B411 – Teversham Road, Fulbourn, Cambridgeshire Reserved Matters Application – Layout Update For Castlefield International Ltd 13th April 2021

This note accompanies an amendment to the Reserved Matters Application (reference S/3290/RM/19) currently under consideration for the permitted development between Teversham Road and Cox's Drove in Fulbourn, Cambridgeshire.

Simple development platform edge treatment illustration

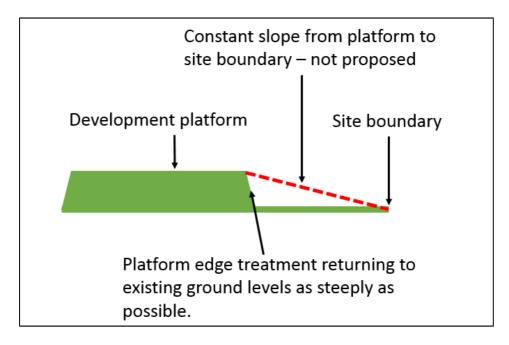
The note addresses flood risk queries raised in January 2021 by local residents. Residents expressed concerns about the potential for site runoff to be directed towards properties on the south-eastern boundary of the site, and the increase in surface water flooding to the south-east of the site which was indicated by the flood modelling (the flood modelling which supported the outline application and the revised flood model prepared and submitted in 2020).

The concern that runoff from the site will be shed overland towards the properties on Cow Lane can be addressed by confirming that it is not proposed create a continuous slope between the edge of the raised development platforms and the site boundary. Proposed ground levels will instead return to existing ground levels (or lower) as 'quickly' as possible (see illustrative sketch below).
